Traffic Control Devices Order, amendment

Regulation 34/2006
Registered February 22, 2006

Manitoba Regulation 264/88 amended

Maximum 40 When Meeting Traffic sign (MR-136 and MR-136F)

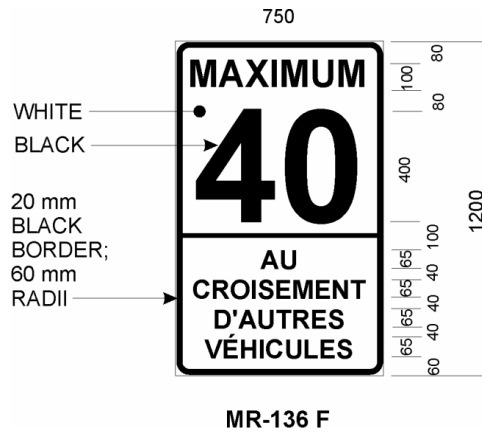
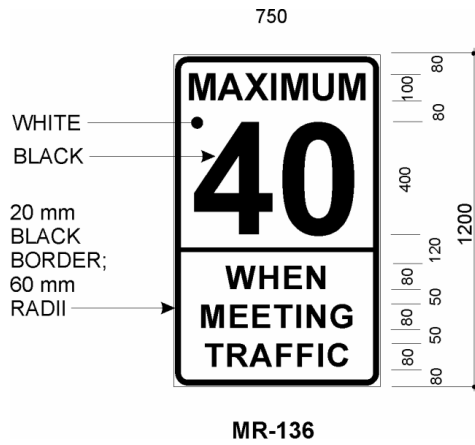
2 **The following is added after section 65.17 of the Schedule:**

65.18(1) A "Maximum 40 When Meeting Traffic" sign may be used to indicate to drivers to reduce their speed when meeting oncoming vehicles within the project limits of seal coat application projects.

65.18(2) A "Maximum 40 When Meeting Traffic" sign shall

- (a) be rectangular in shape and erected so that the long dimension is vertical;
- (b) be not less than 750 mm in width and 1200 mm in height;
- (c) be white in colour and display the word "Maximum" in black upper case letters not less than 100 mm in height, the figure "40" in black figures not less than 400 mm in height and the words "When Meeting Traffic" in black upper case letters not less than 80 mm in height;
- (d) be available in a bilingual format as shown in the illustration;
- (e) be reflectorized to show the same colour and shape by night as by day; and
- (f) bear the markings and have the dimensions illustrated in the following figure:
